AMENDMENT NO. 26

Incidental Take Permit No. 2081-2015-024-04

California High-Speed Train Project Fresno to Bakersfield Section Permitting Phase 1

High-Speed Train Fresno to Bakersfield Construction Footprint CP2-3 & CP4

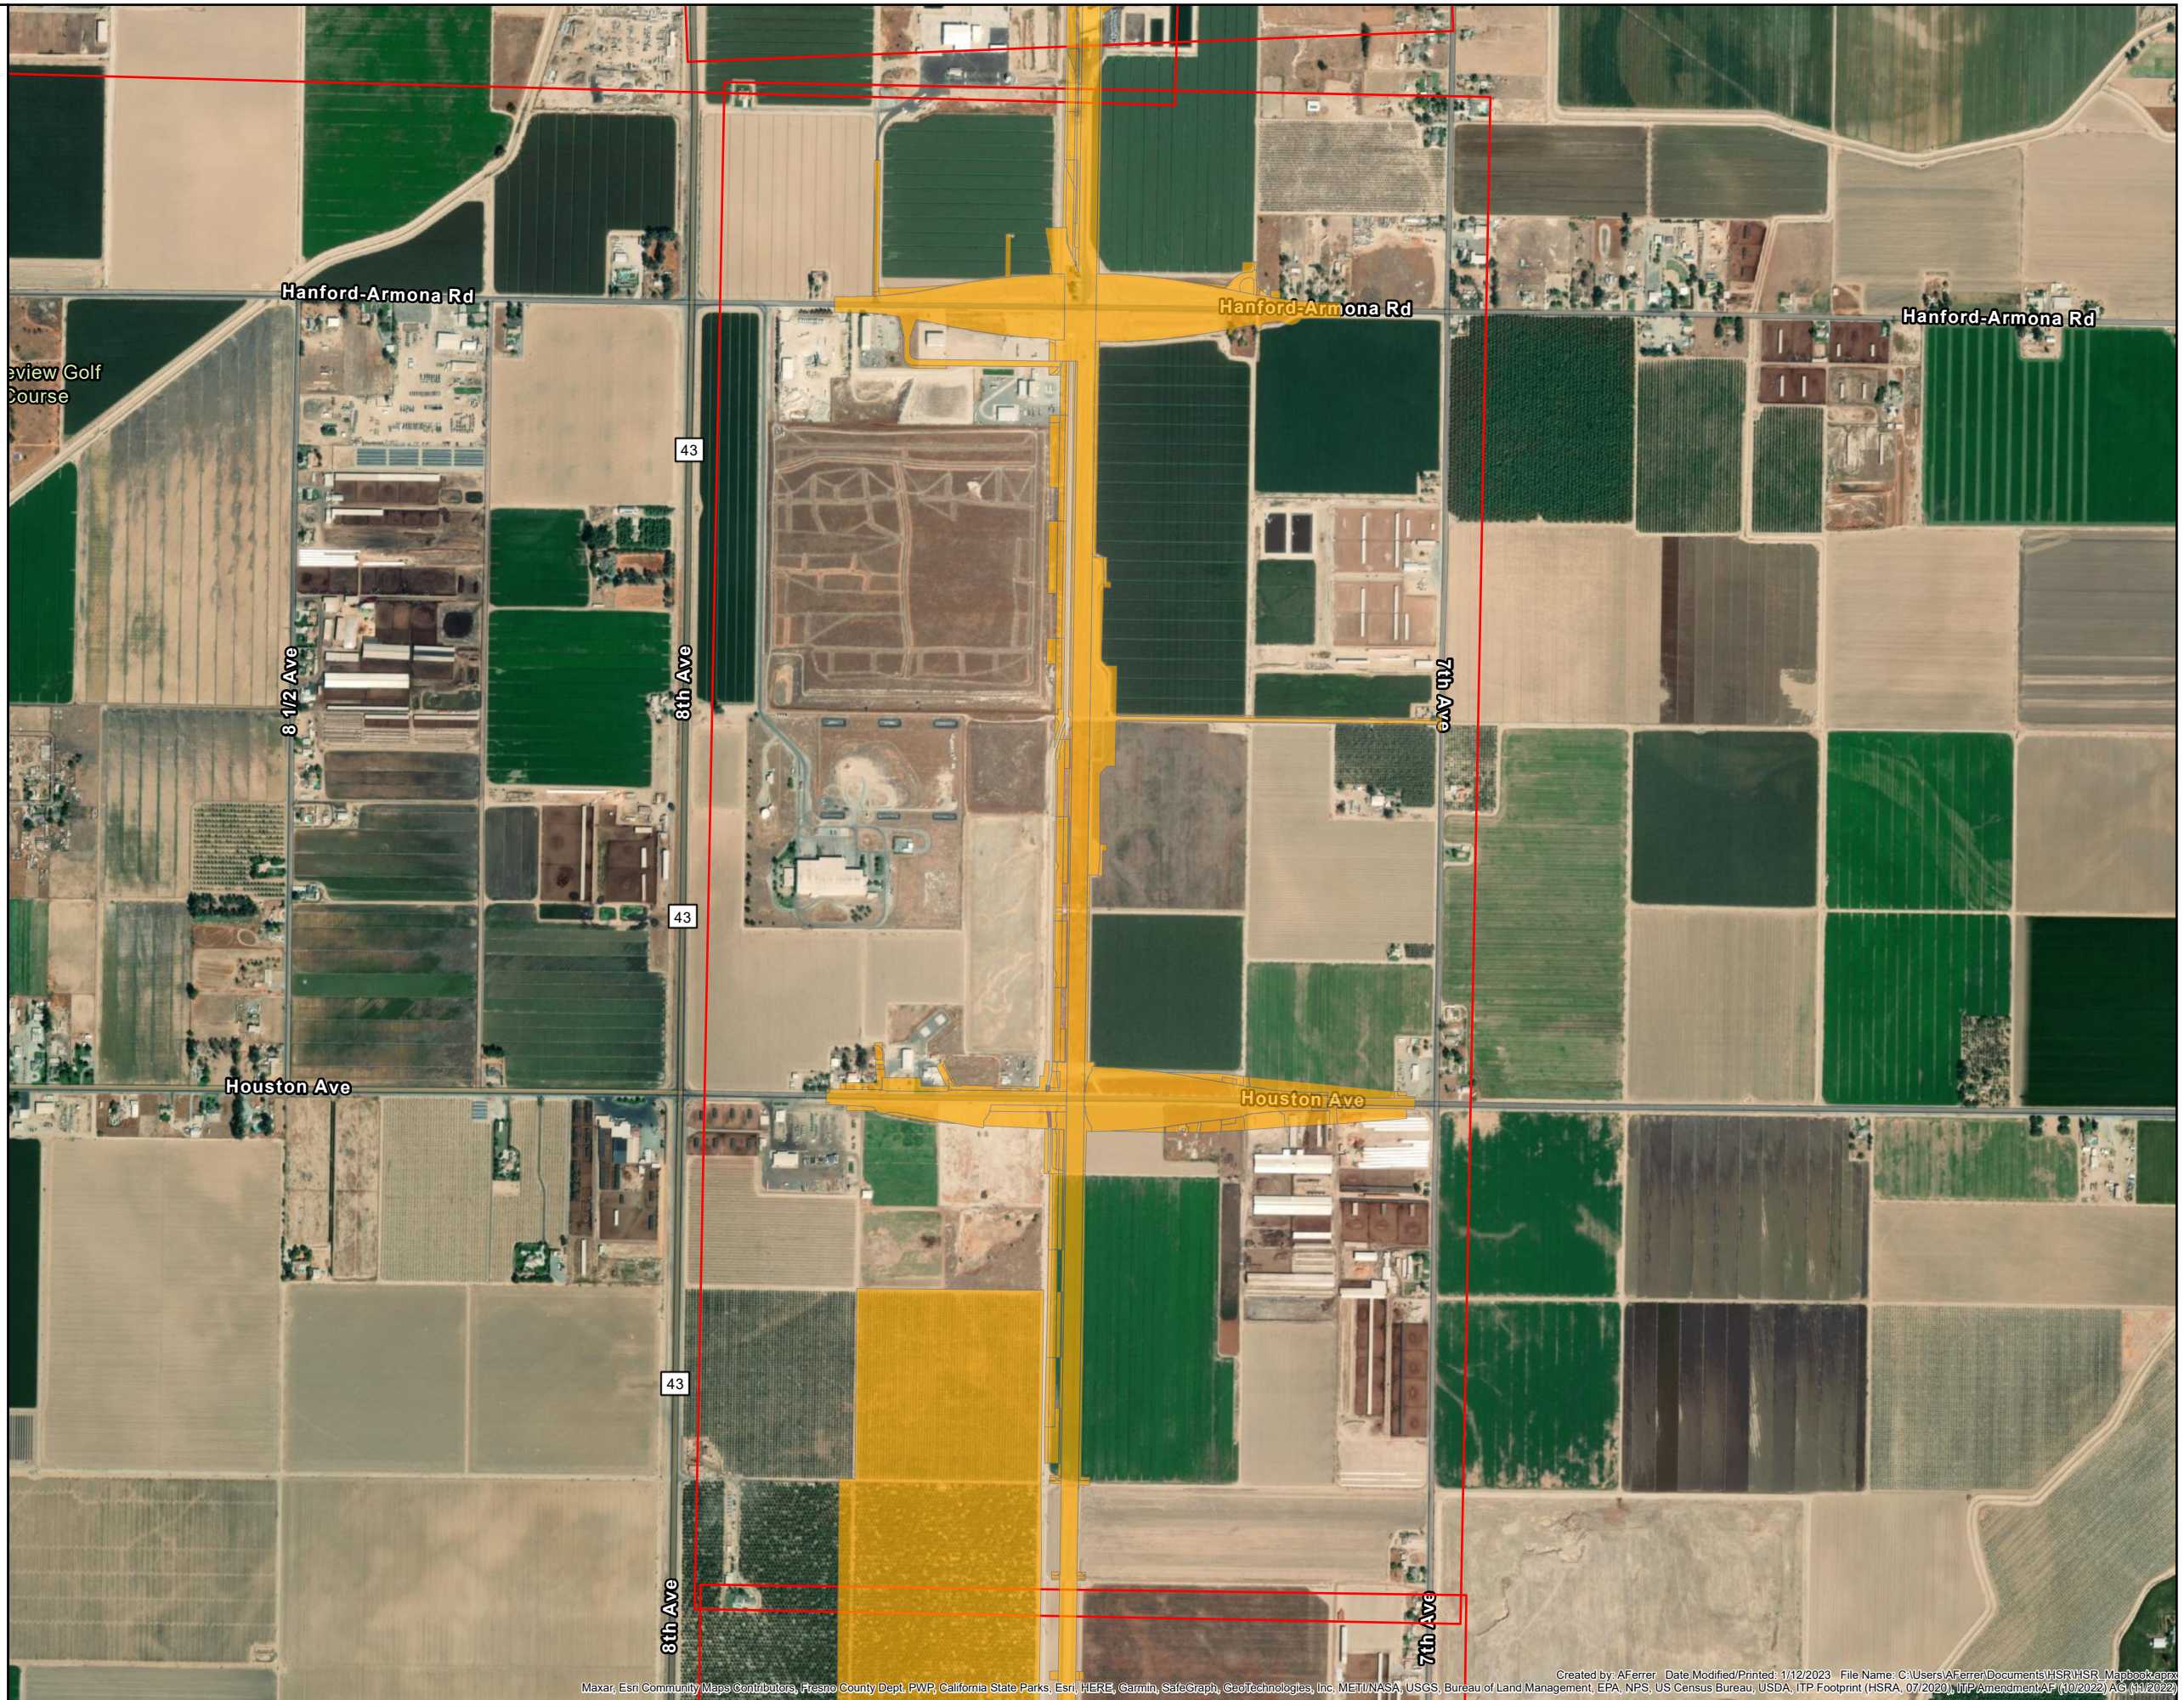
- 10) This Amendment modifies Exhibit 6, the "Baseline Map Book," by replacing Map Book Pages 20, 39, 40, and 42 to reflect the increased Project Construction Footprint.

- Amendment 26
- ITP Footprint
